# STATE OF OHIO DEPARTMENT OF TRANSPORTATION

## GRE-68-12.65

### BUILDABLE UNIT #3 AND #4

**INTERIM SUBMITTAL  
DATE: 02/17/2025**

**DECK POURING SEQUENCE PLAN**

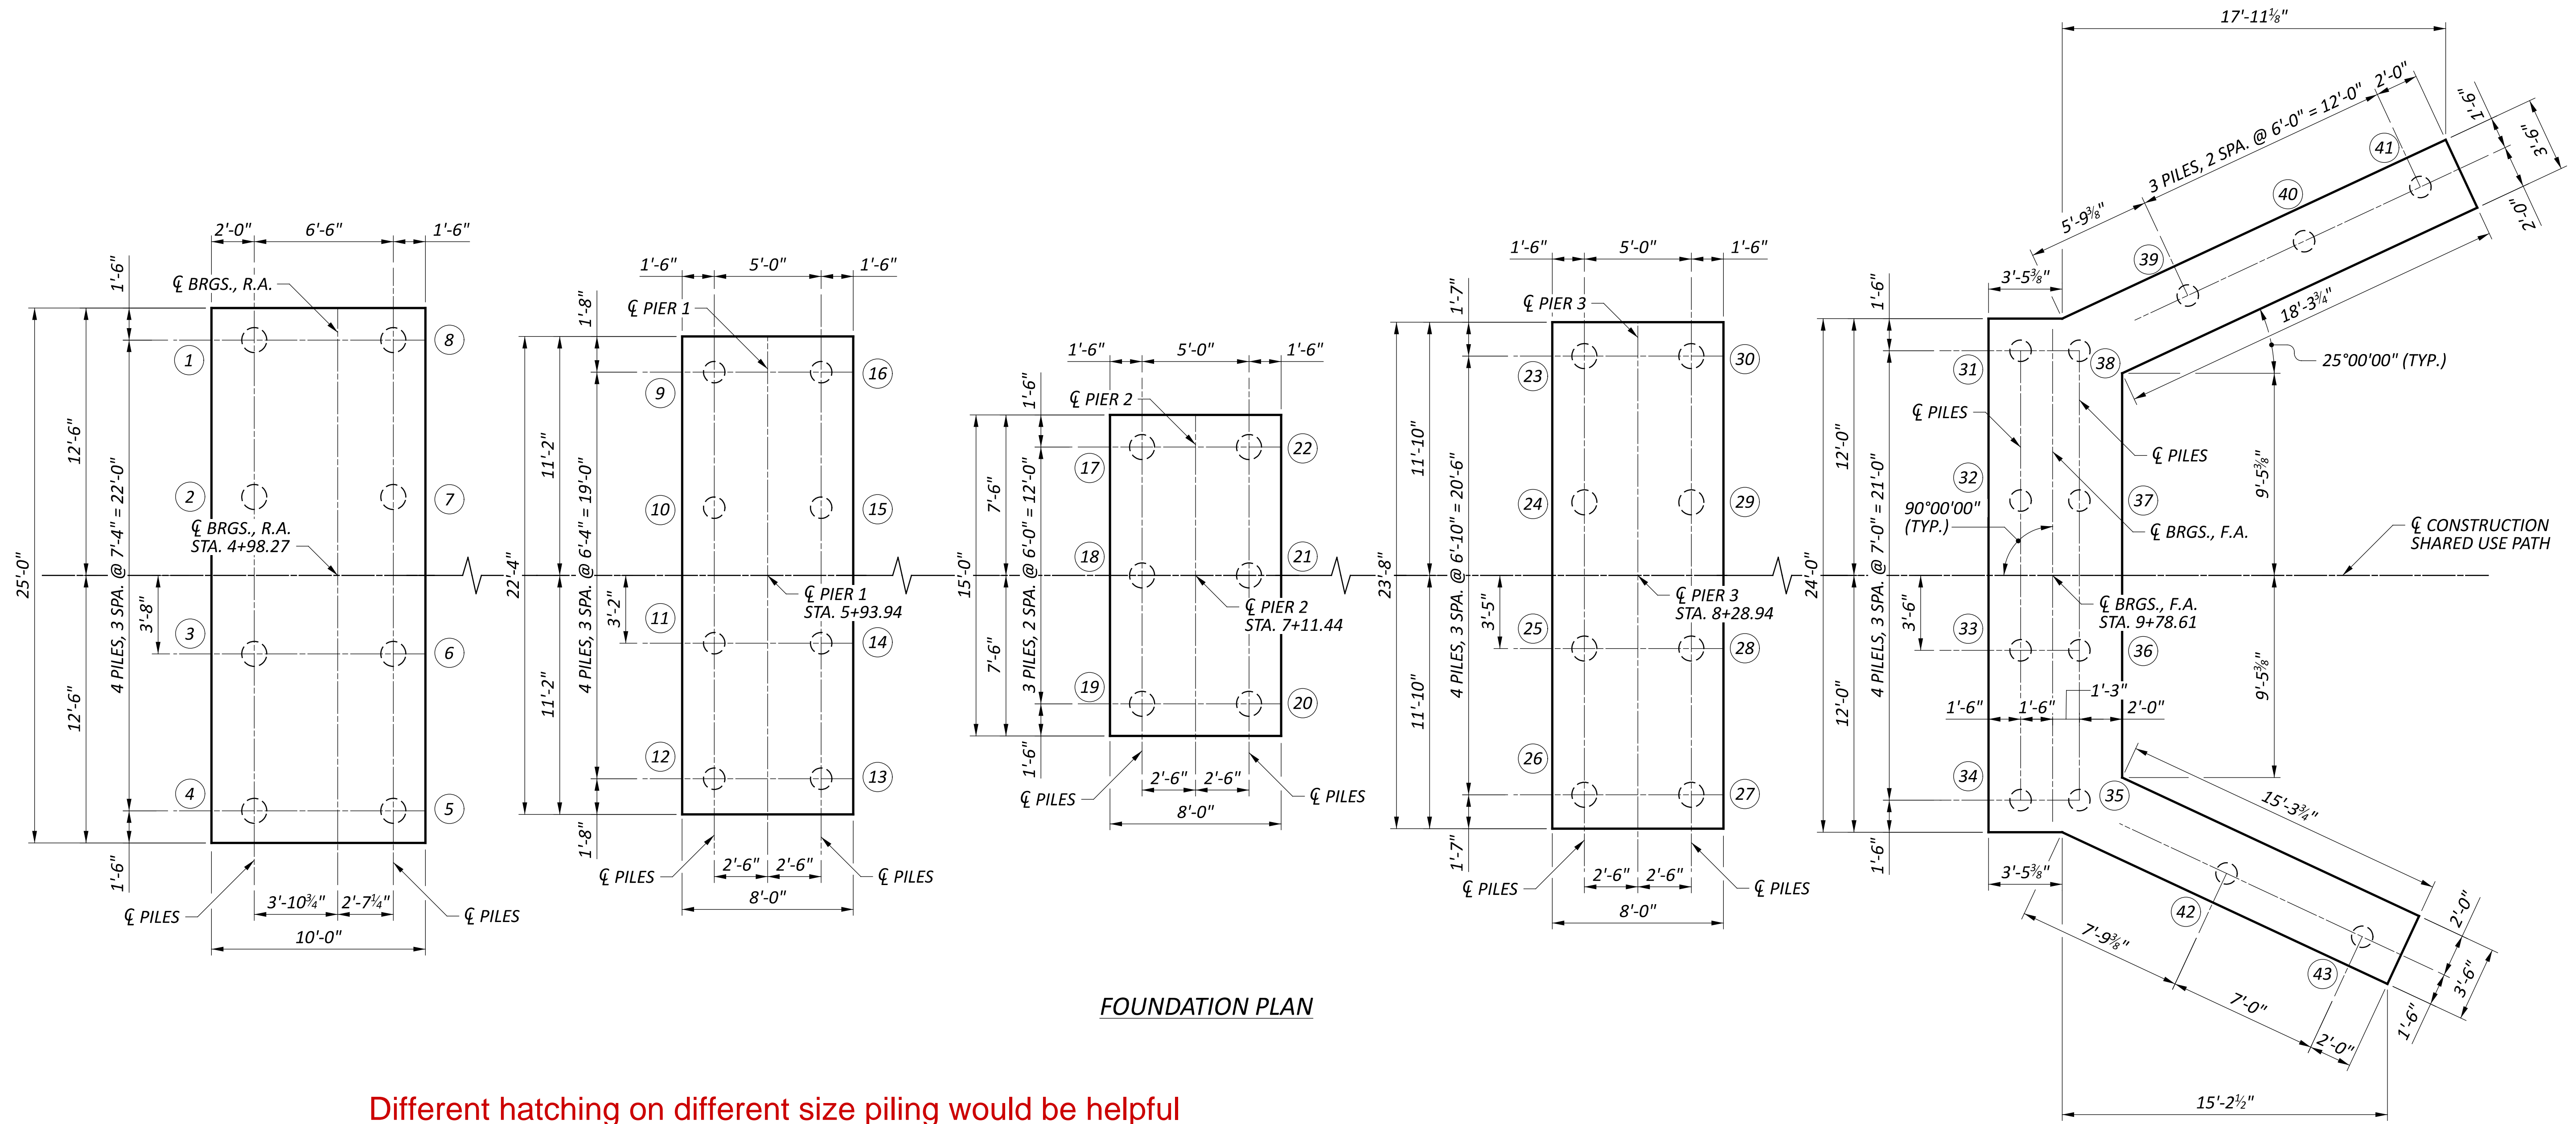
Any Pile Driving Constraints?

I would only have them do this if it was required in the scope since this is DB.

Provide Bridge Estimated Quantities in future submittal

SFN	2926107
DESIGN AGENCY	CARPENTER MARTY
DESIGNER	CHECKER
SMH	AMR
REVIEWER	
GDJ	02/10/25
PROJECT ID	1153888
SUBSET	TOTAL
4	25
SHEET	TOTAL
P.46	P.83

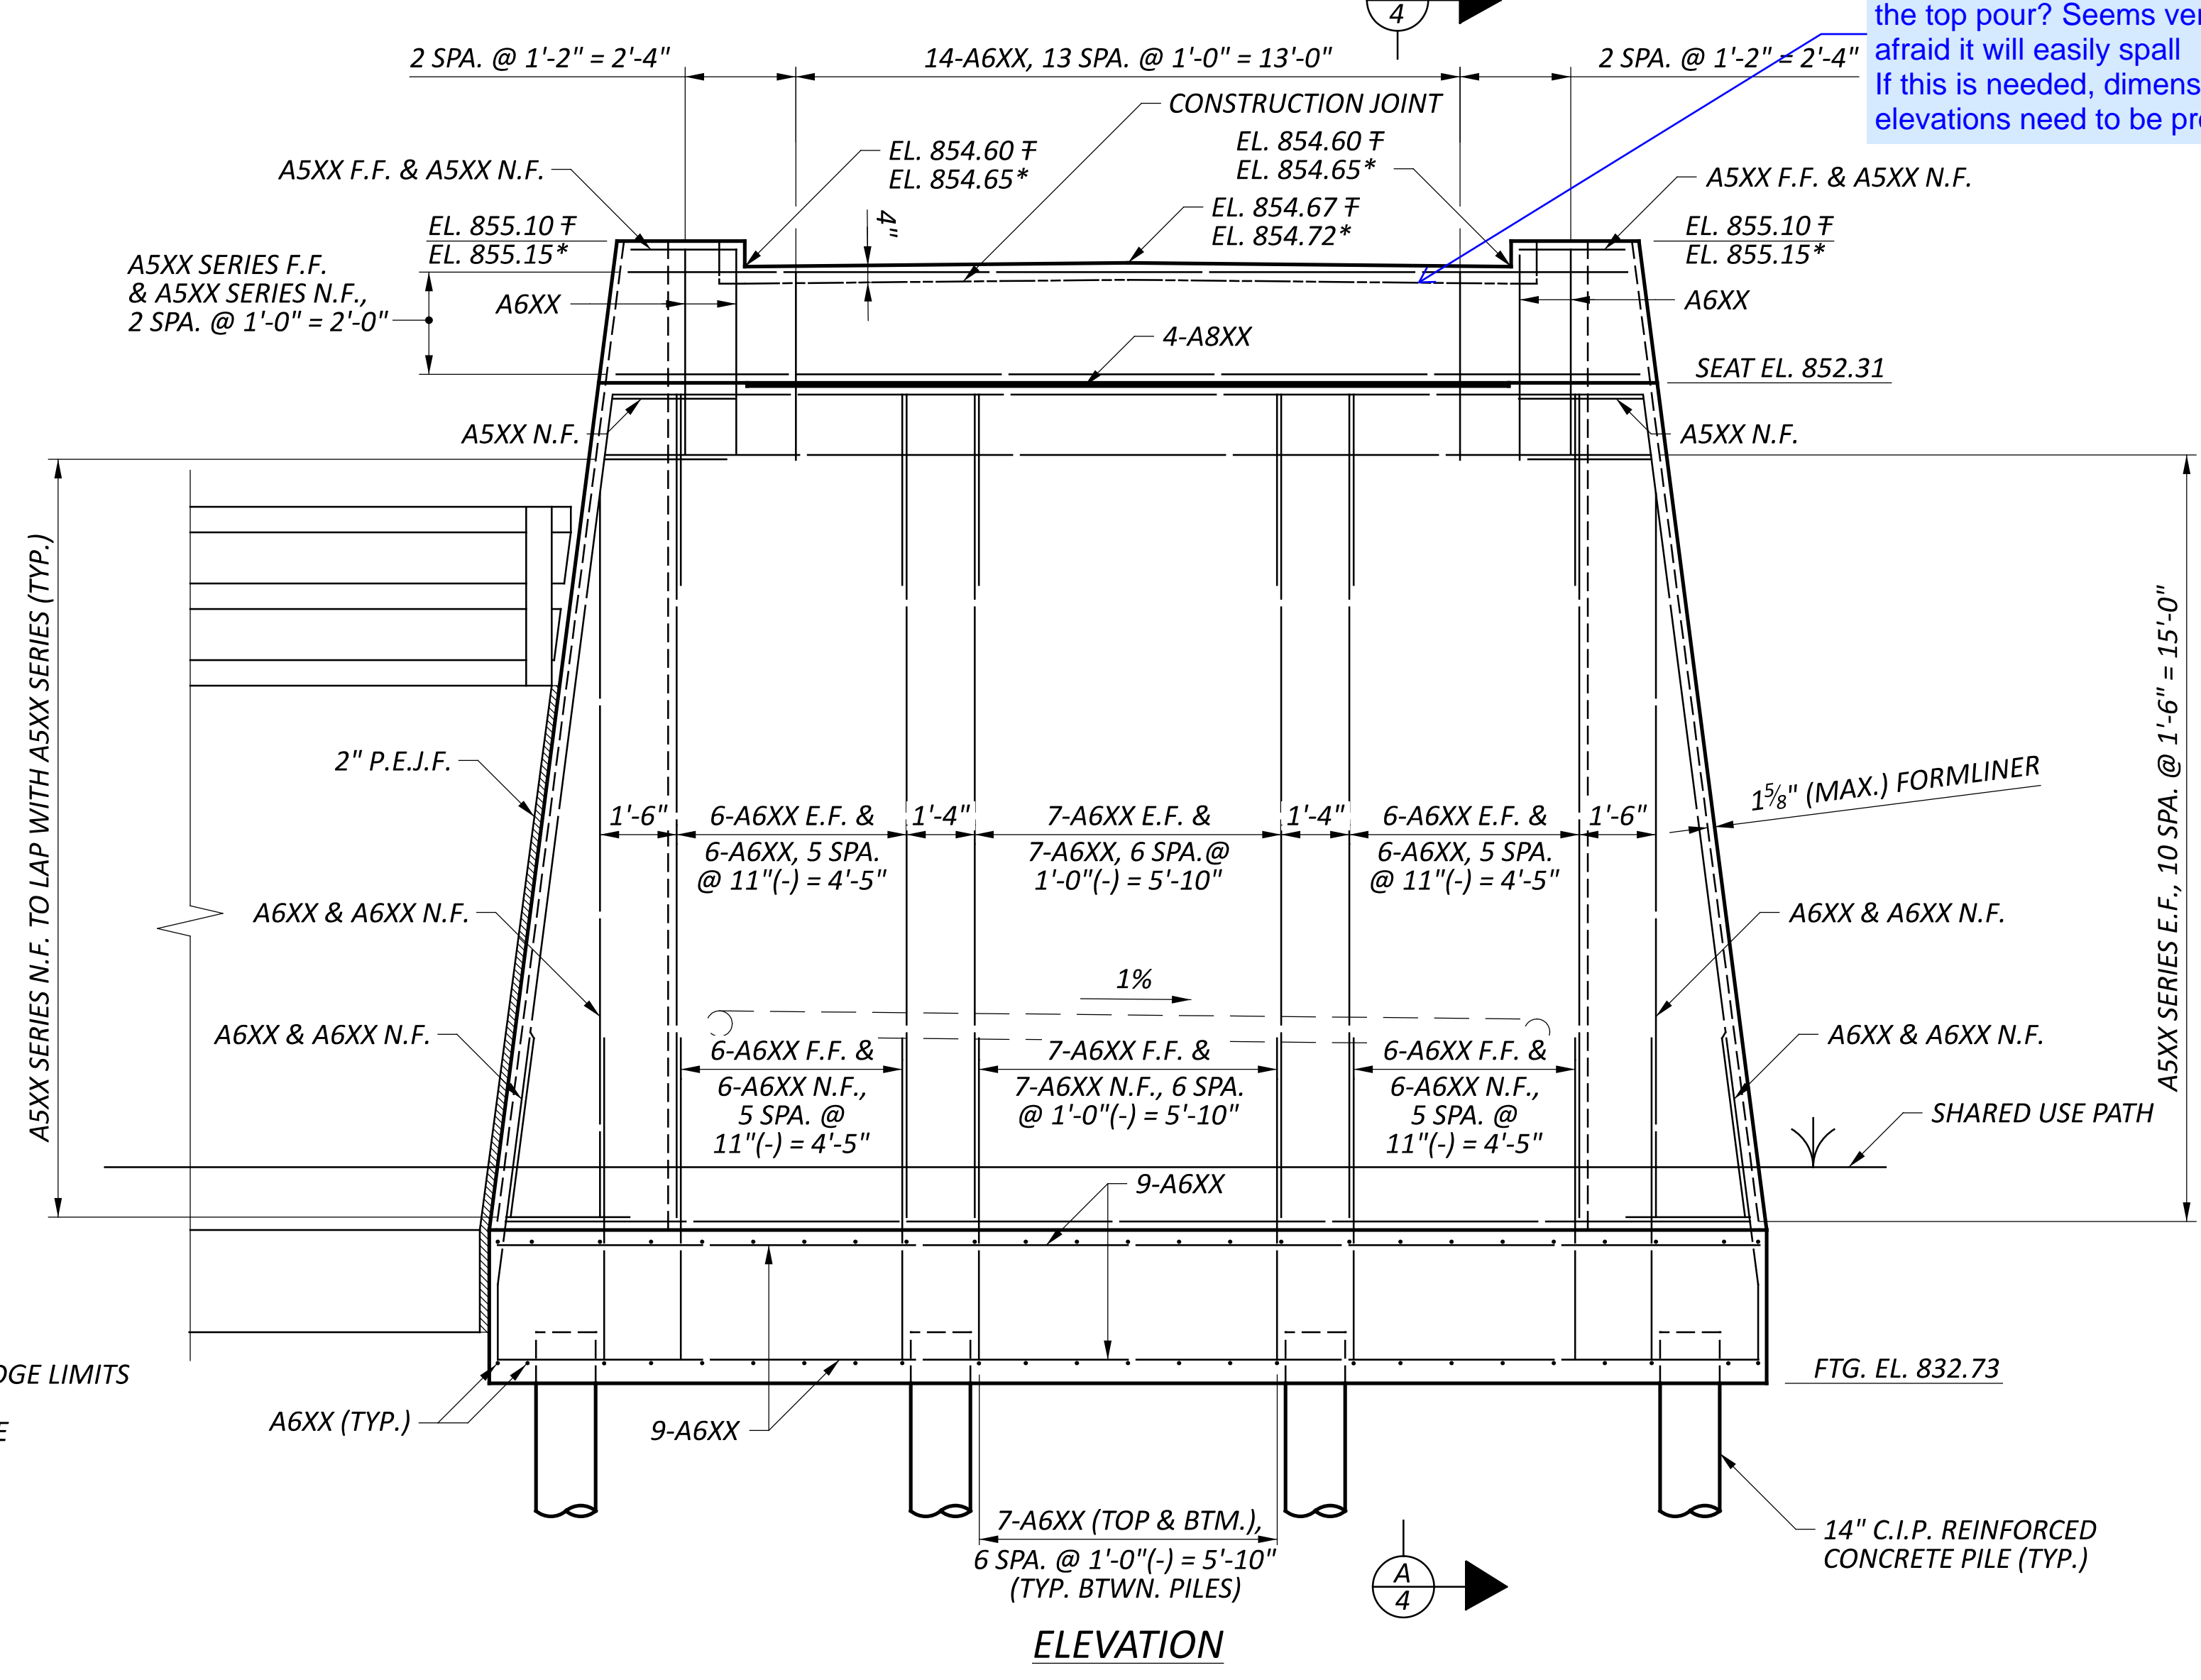
what is this "cut-out" for?  
 Need to detail dimensions, etc

why the need for a construction joint here? What will be the thickness of the top pour? Seems very small and afraid it will easily spall  
 If this is needed, dimensions or elevations need to be provided

SFN 2926107	
DESIGN AGENCY	
DESIGNER SMH	CHECKER AMR
REVIEWER	
GDJ 02/10/25	
PROJECT ID 115388	
SUBSET 7	TOTAL 25
SHEET P.49	TOTAL P.83

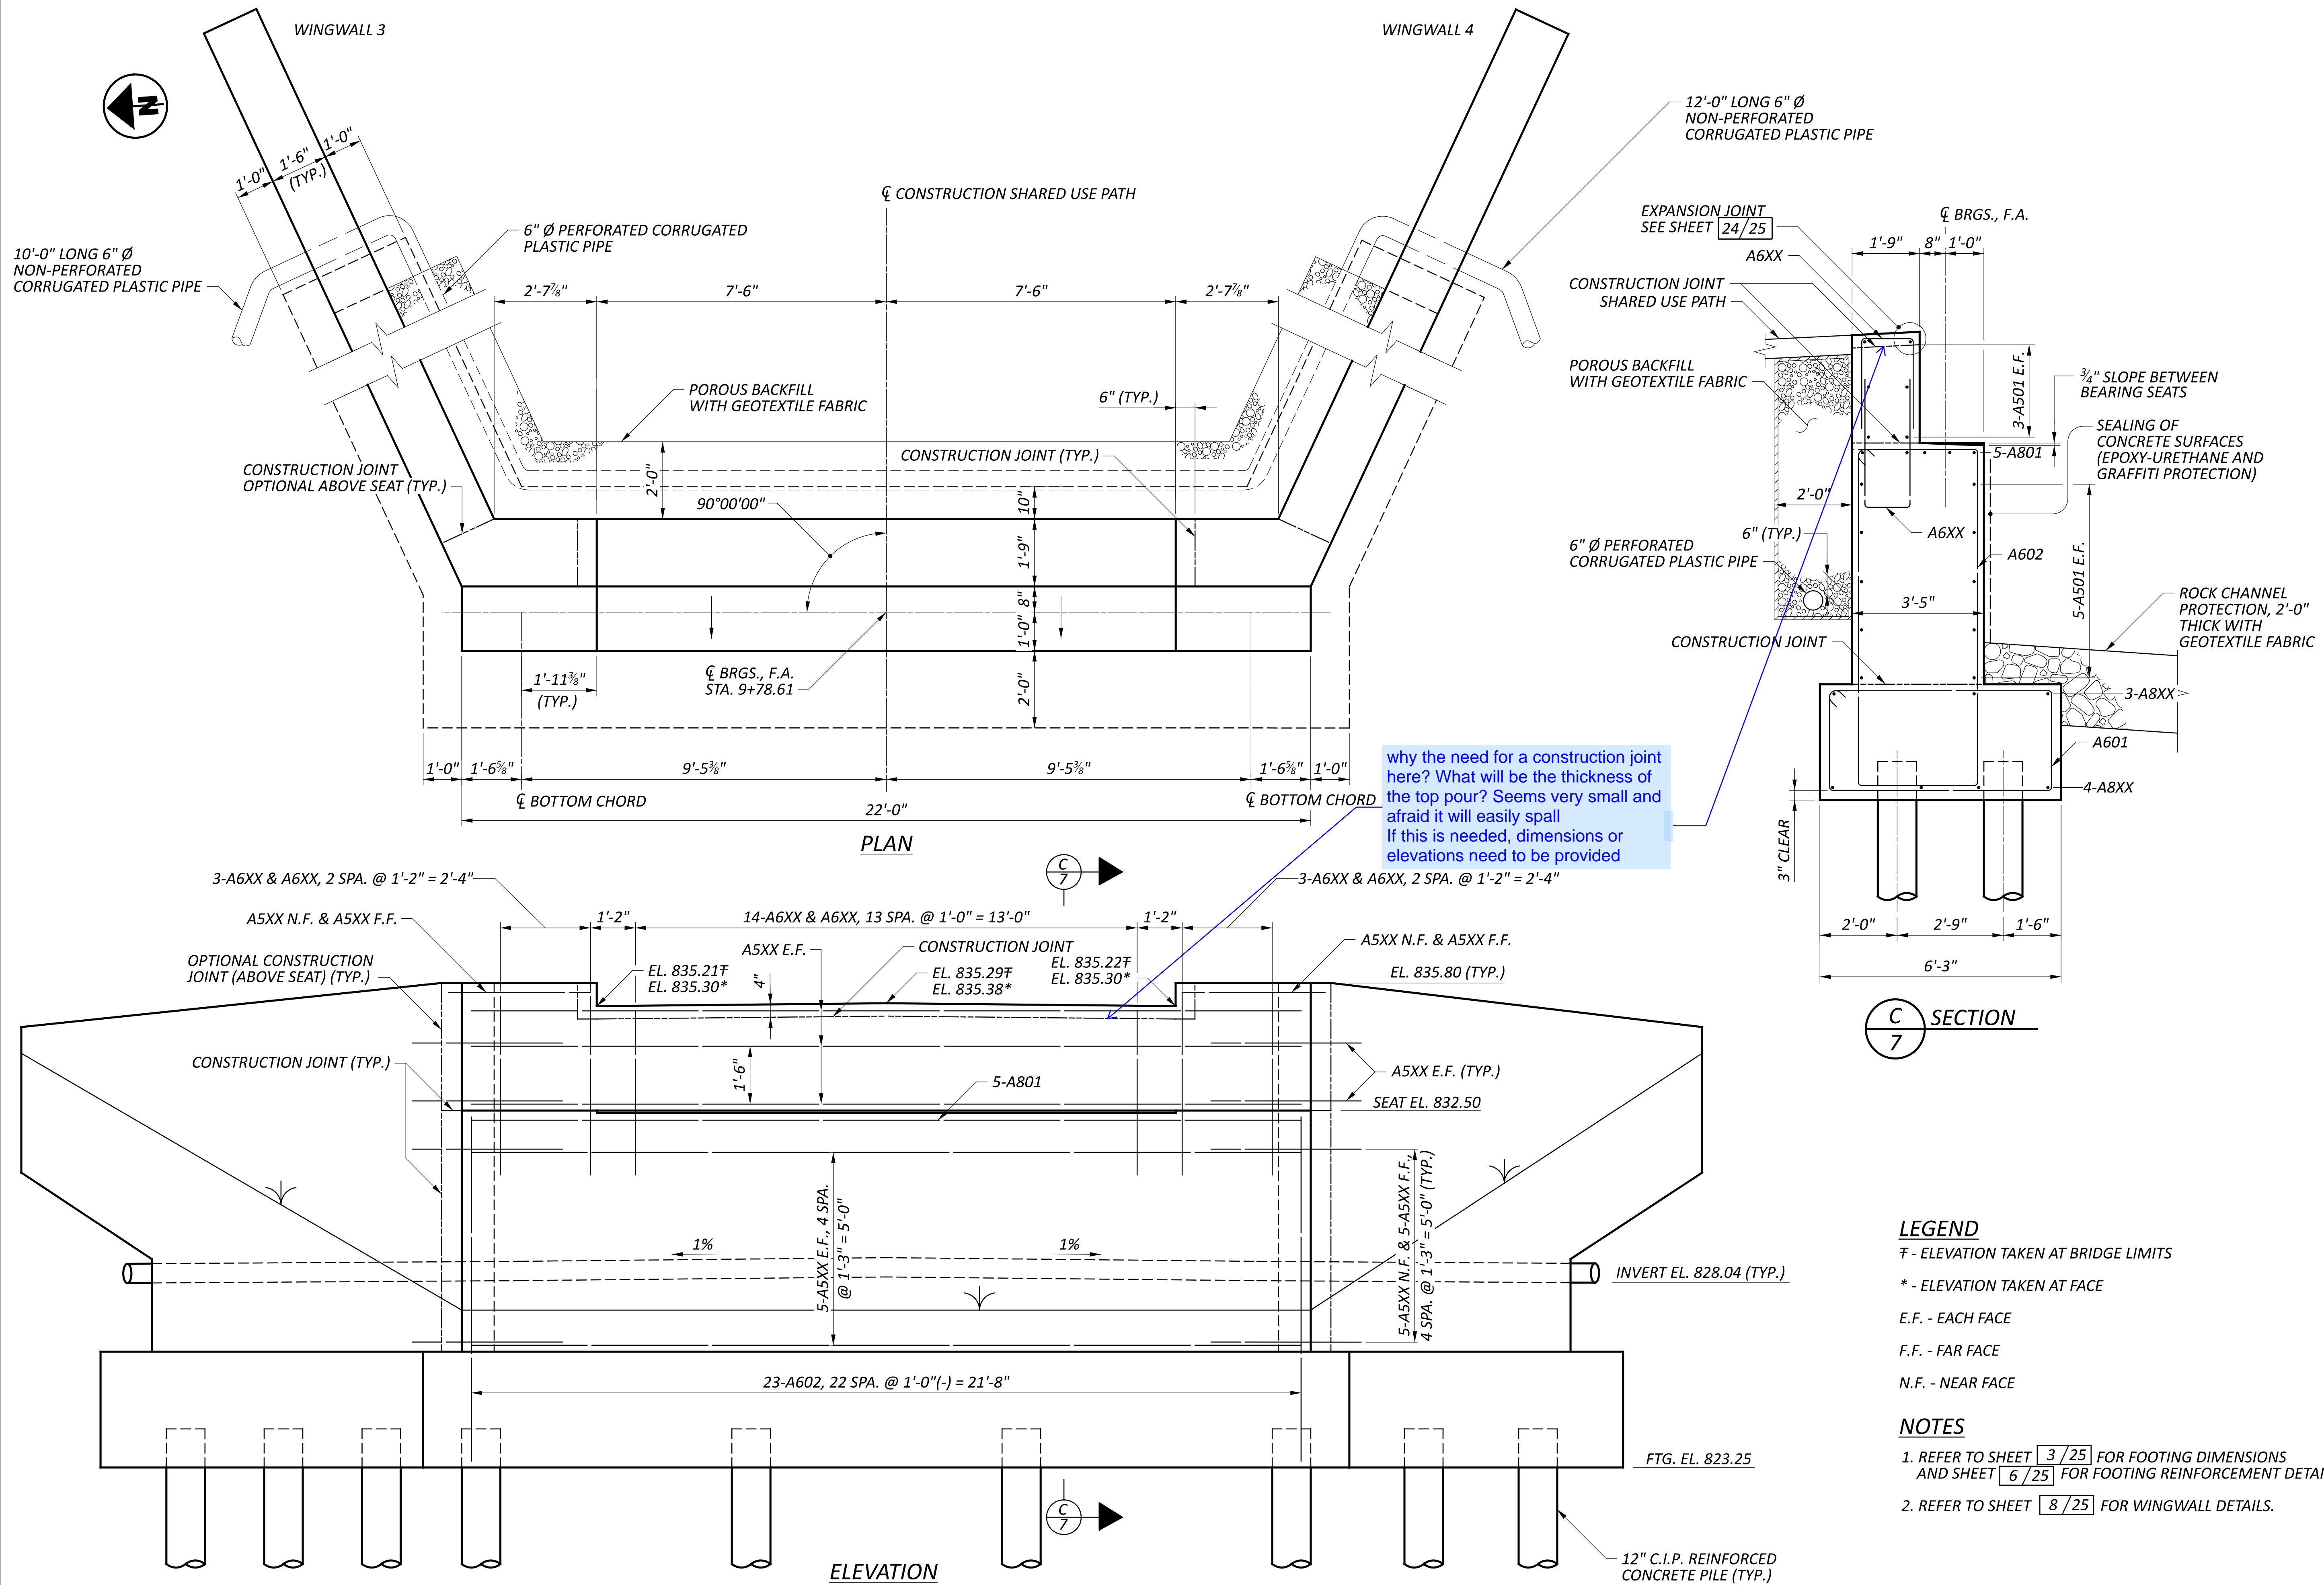
why the need for a construction joint here? What will be the thickness of the top pour? Seems very small and afraid it will easily spall  
 If this is needed, dimensions or elevations need to be provided
